Darling Square NW Plot
Design Report for Section 96 Application
(Mod 3) To Modify SSD 6013
October 2016

Approval for SSD 6013 Mod 2 was granted on 26 November 2015. This report has been prepared to support a section 96 application. It describes a range of minor amendments as the result of design development for the project.

Figure 2.02 : Section 96 NW Plot Proposed Dicksons Lane South East Corner

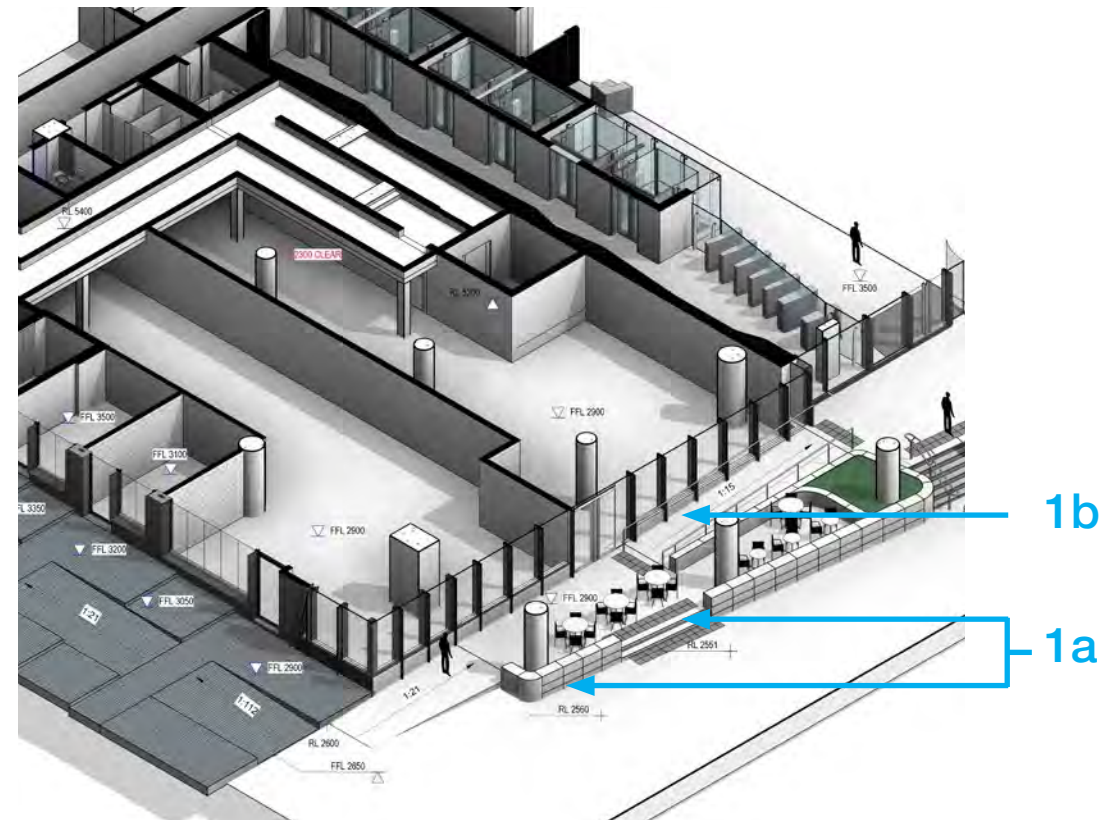
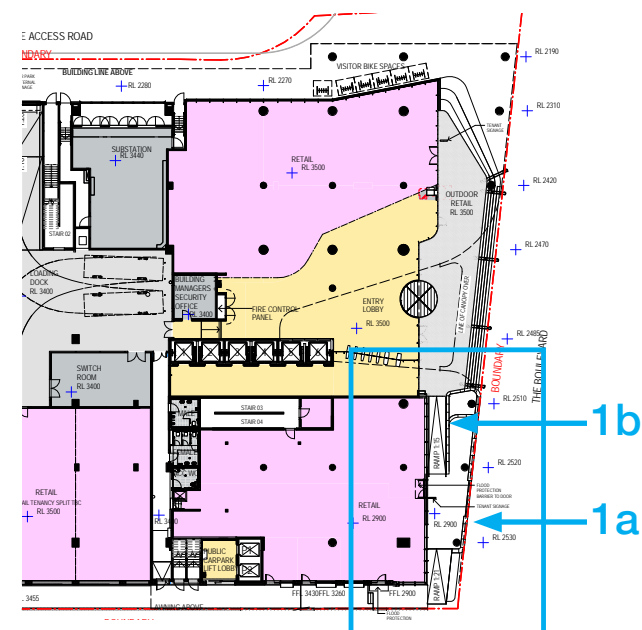
The structure has been reconfigured to strengthen the connection between the corner of the building and the Boulevard, including:

- 1(a) The structural beam along the edge of the building has been rationalised to open the corner and allow for stair access from the Boulevard to the adjacent retail; and
- 1(b) The ramped pedestrian walkway has been reconfigured to allow for a flat seated area adjacent to the Boulevard.

Figure 2.05 : Section 96 NW Plot Proposed Detail of Flood Gate Precedent Images

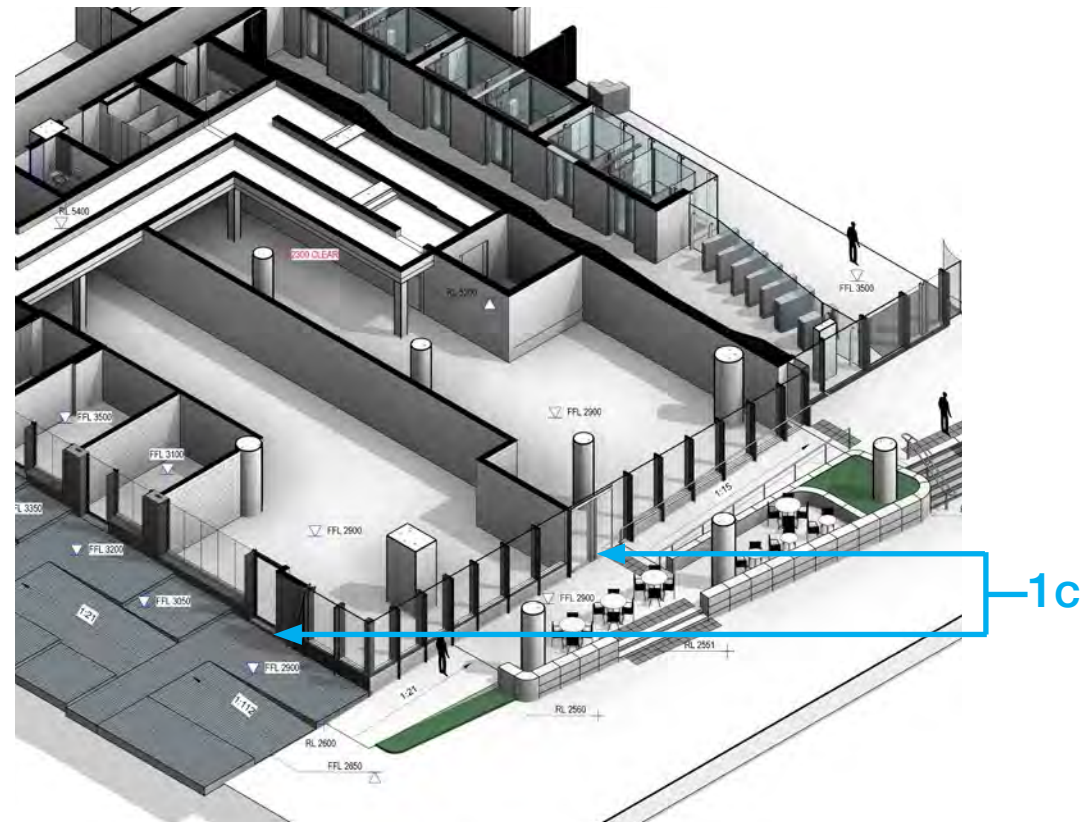
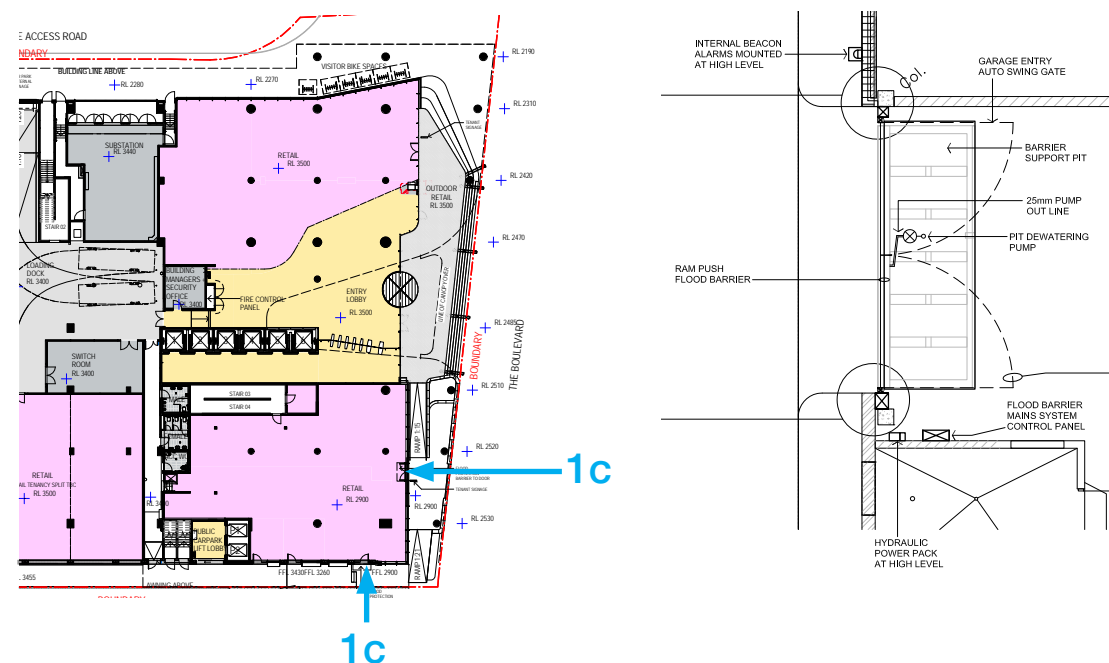
1(c) Mechanically controlled flood barriers have been specified at two of the South East retail entries to address 1 in 100 year flooding requirements for the project. The concealed barriers are integrated into the ground structure with consistent floor finish to ensure minimal impact aesthetically.

The barriers are independently operated via a flood control system. A sensor is included in a remotely located pit and when the sensor is activated in flood conditions the floor barriers raise. A backup power provision is also included in the event of building power failure. These flood barriers are a refinement of the approved flood mitigation strategy. The refinement of these details has been possible through the detailed design process.

Figure 2.06 : Section 96 NW Plot Proposed View from the West showing Bioswale

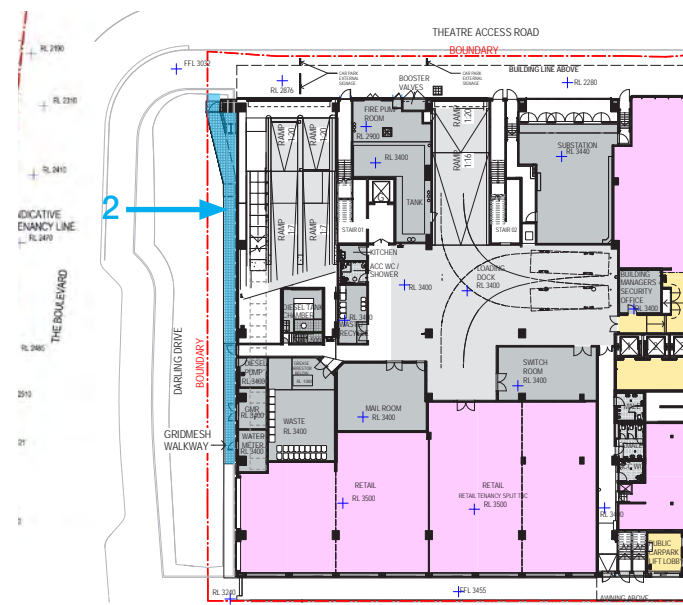
The cantilevered walkway along the Western facade which serves as fire escape and maintenance walkway has been redirected towards Theatre Lane. Previously this walkway was diverted to the South West corner fronting Dixons Lane. The proposed change will ensure a more defined and strong architectural corner is created at Dicksons Lane.

The walkway is to be constructed from lightweight painted steel that follows the line of the building whilst allowing the adjoining bioswale to fully function.

Figure 2.07 : Section 96 NW Plot Proposed South Elevation

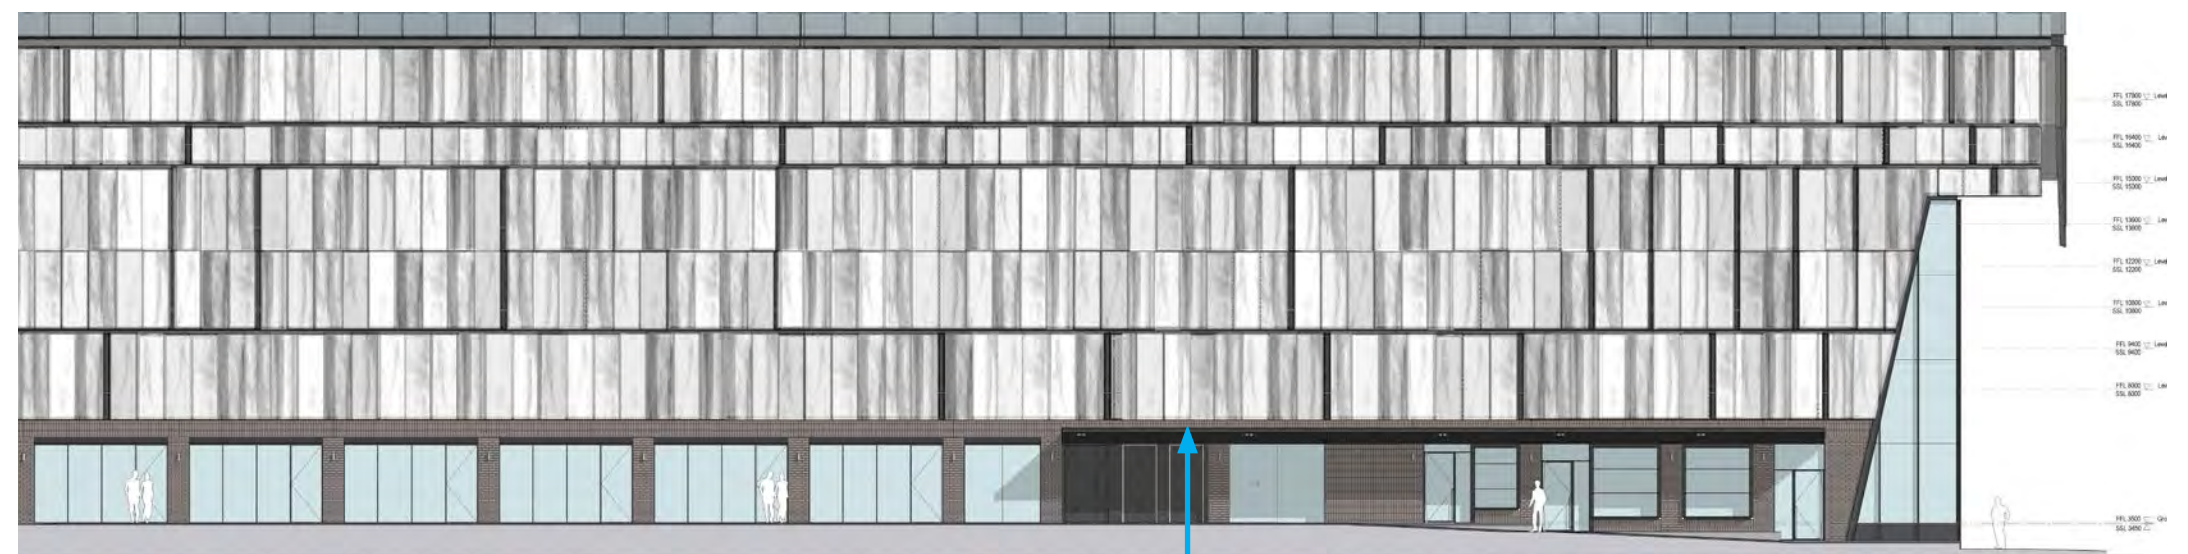
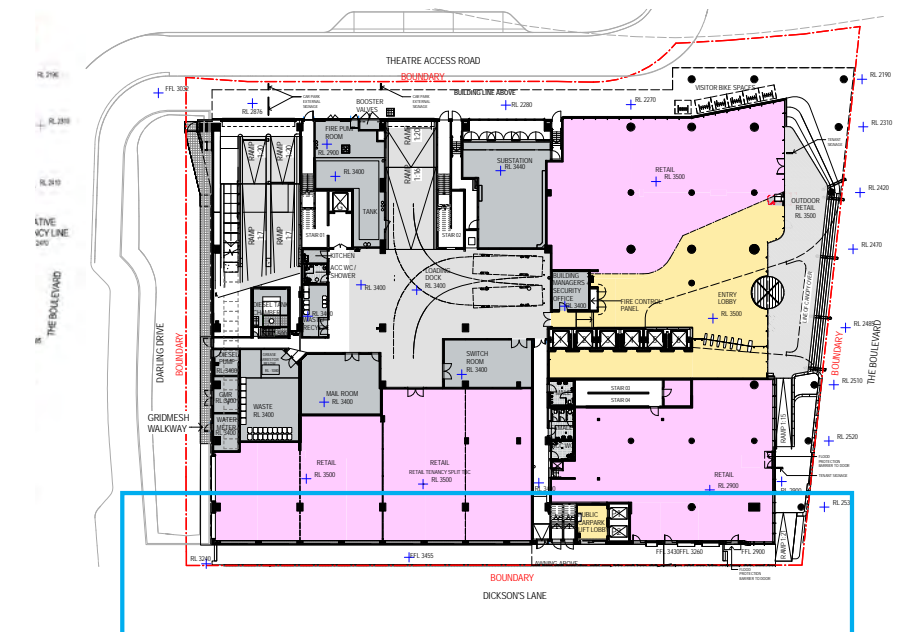
The south elevation at ground level has been crafted to better respond to the laneway environment of Dicksons Lane and better activate the retail and pedestrian atmosphere desired. The materiality has been inspired by the urban context including numerous existing brick buildings. The design consists of a series of brick portals which bring the building to ground and allow for different façades to be inserted between the portals.

Retail façades for tenancies east of the carpark lobby have been designed to have a combination of filigrane steel and glazing. For consistency, the material of the car park entry lobby cladding has been changed to brick. The awning that defines the laneway entry from the Boulevard has been adjusted in length to better define the strength of the south east retail corner.

The awning has also been adjusted in height and materiality to provide a more human scale to the laneway below. The materiality will become clad metallic finish with decorative perforation to the underside and includes glazed sections to allow light penetration and connection visually to the building above.

Figure 2.09 : Proposed North Part Elevation Nominating Stone Material

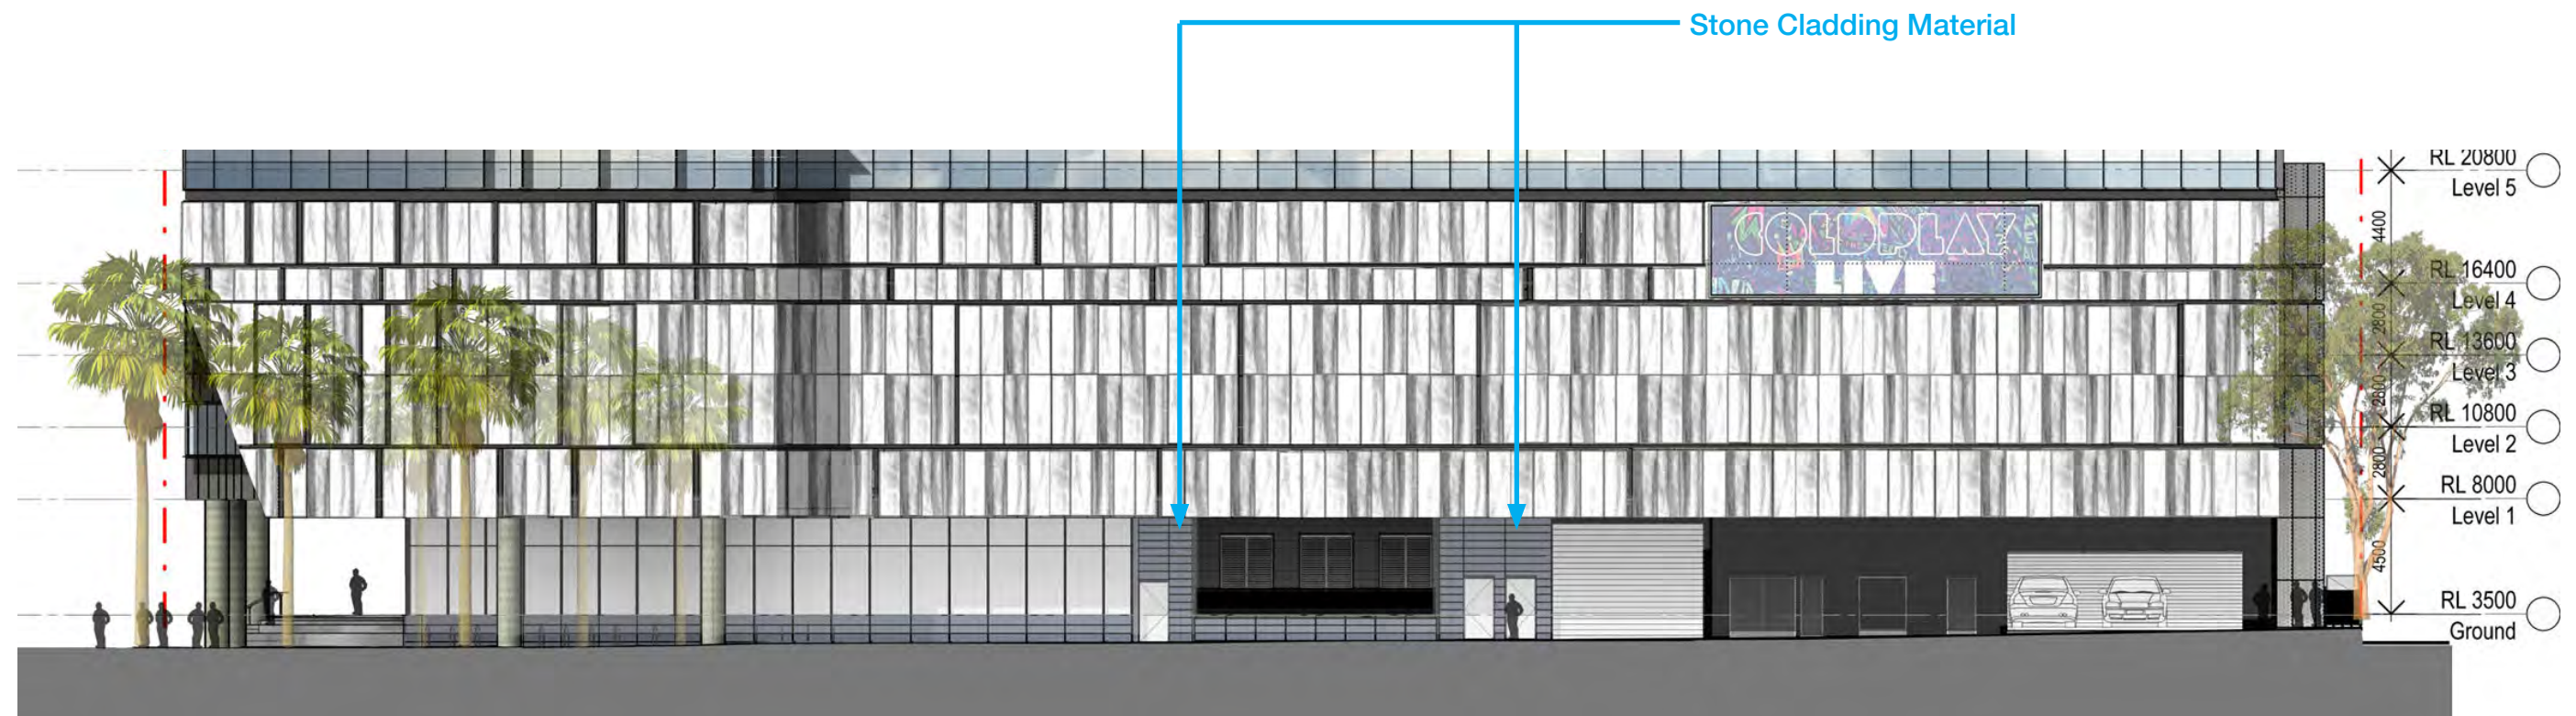
After ongoing design development in conjunction with Ausgrid the requirement for louvres to the Ground Floor has been rationalised. Where there were previously louvres, stone cladding material has been incorporated. The reveal will be rendered finish to complement the materiality of the surrounding architectural elements. The stone finish has been selected to provide consistent materiality of the podium plinth that continues around from the North to the Eastern Boulevard location.

Figure 2.10 : Location of Retail Tenancy Identification Signs

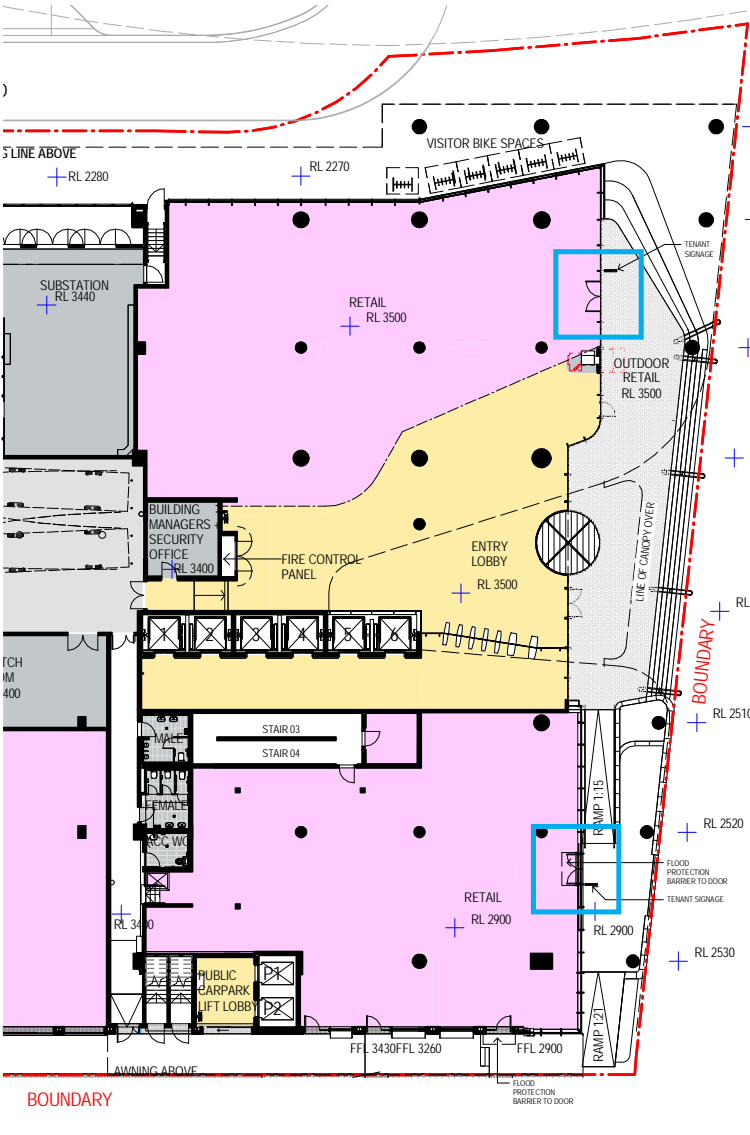
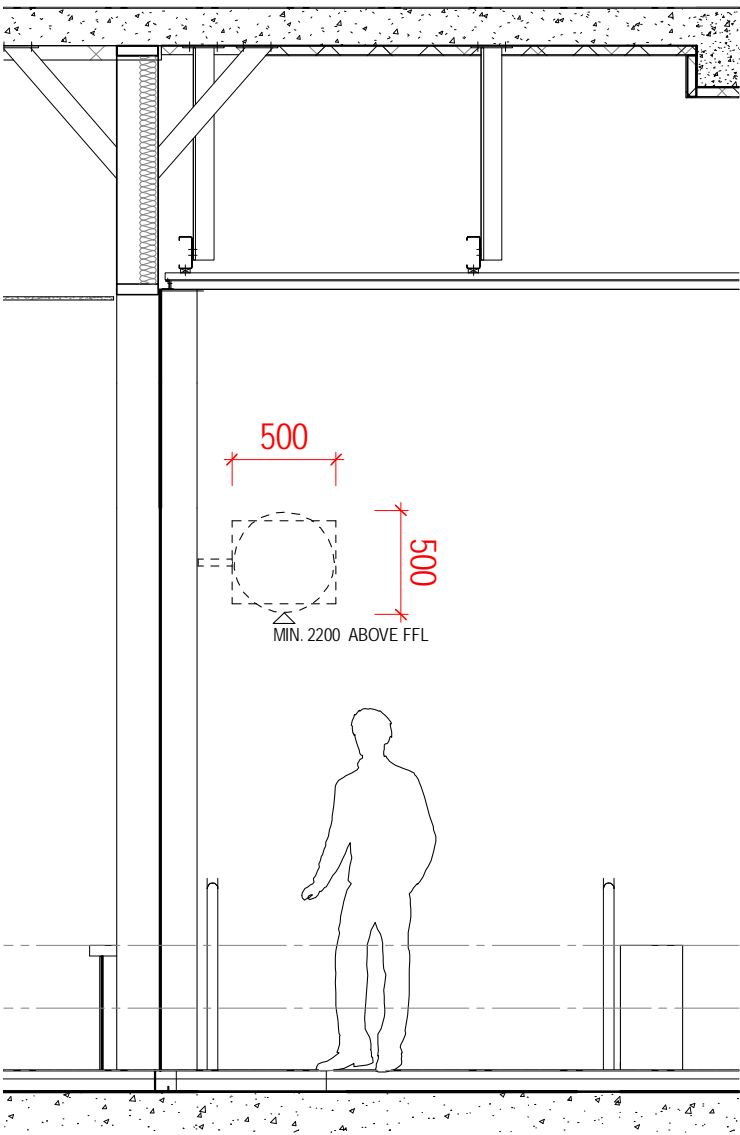
The retail tenancy identificaiton signage zones are proposed for the two retail tenancies that have entries off the east facade building undercroft. The signs will be fixed to the mullions and will be a maximum size of 500 mm wide x 500 mm deep x 200 mm thick. Final tenancy details will be submitted to the Secretary General for endorsement prior to construction.
